**Work Order ID 92597**

Item Name: 205 Skidtube bent detail

DRAWING NO. D2580	TITLE 205 SKIDTUBE ASSEMBLY	REV. E	DART AEROSPACE LTD ENGINEERING ORDER	D.E.O. NO. D2580-E-1	SHEET NO. SHEET 1 OF 1	SCALE NTS
DRAWN <i>UP</i>	CHECKED <i>ASS</i>	MFG. APPR. <i>EC</i>	APPROVED <i>HA</i>	DE APPR. <i>HA</i>		
DATE 11.12.13	DATE 11.12.13	DATE 11.12.13	DATE 11.12.13	DATE 11.12.13

CHANGE ALL C'BORED WELDED CROSSBOLT SPACERS TO SWAGED SPACERS

**SECTION B-B, F-F, I-I**  
NOT TO SCALE

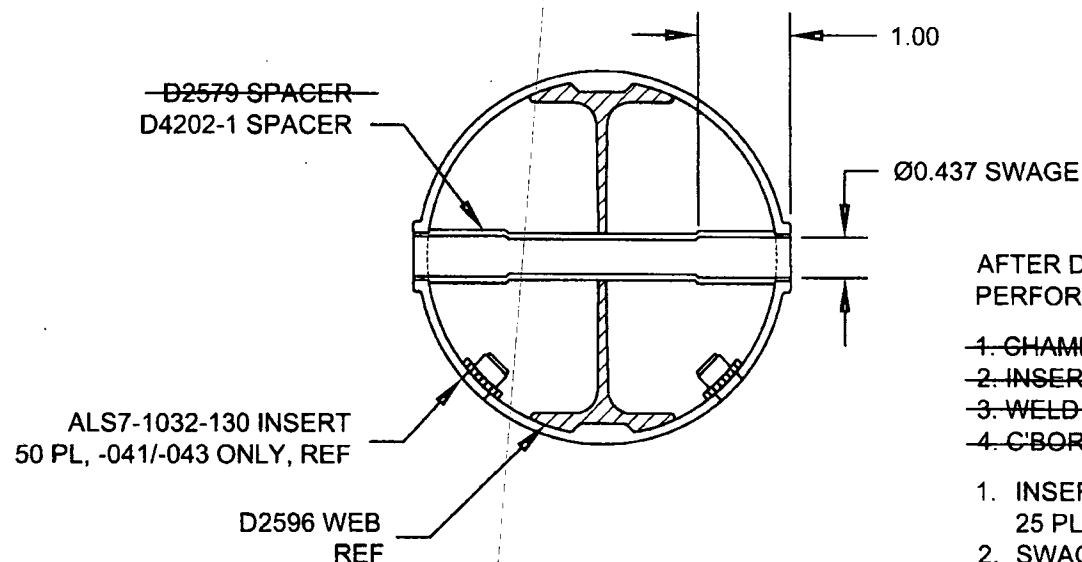
**PURPOSE:**

PARTS LIST IS AMENDED AS FOLLOWS:

**WAS**

QTY	QTY	QTY	PART NUMBER	DESCRIPTION
-041	-045	-047		
20	24	25	D2579	CROSS BOLT SPACER

SECTION B-B, SECTION F-F, & SECTION I-I ARE AMENDED AS FOLLOWS FOR ALL HOLES THAT WERE ORIGINALLY C'BORED:

AFTER DRILLING AND BENDING ASSEMBLY  
PERFORM THE FOLLOWING FOR Ø0.508 HOLES ONLY:

1. CHAMFER HOLE 0.050 X 45°
2. INSERT D2579 SPACER (20 PLACES)
3. WELD INTO PLACE AND GRIND FLUSH
4. C'BORE D2579 SPACER TO Ø0.437 X 1.00 DEEP

**IS**

4		* D2579	CROSS BOLT SPACER
20	20	25	D4202-1	SPACER

**\* FOR -045 SKIDTUBE ONLY:**

WELD 4X D2579 SPACERS PER DWG IN LOCATIONS MARKED "NO C'BORE".  
REF SHEET 4 OF DWG.

1. INSERT D4202-1 SPACER, 20 PL (-041) OR 20 PL (-045) OR 25 PL (-047)
2. SWAGE TO Ø0.437 X 1.00 DEEP PER QSI 002
3. TRIM / GRIND FLUSH PER QSI 002
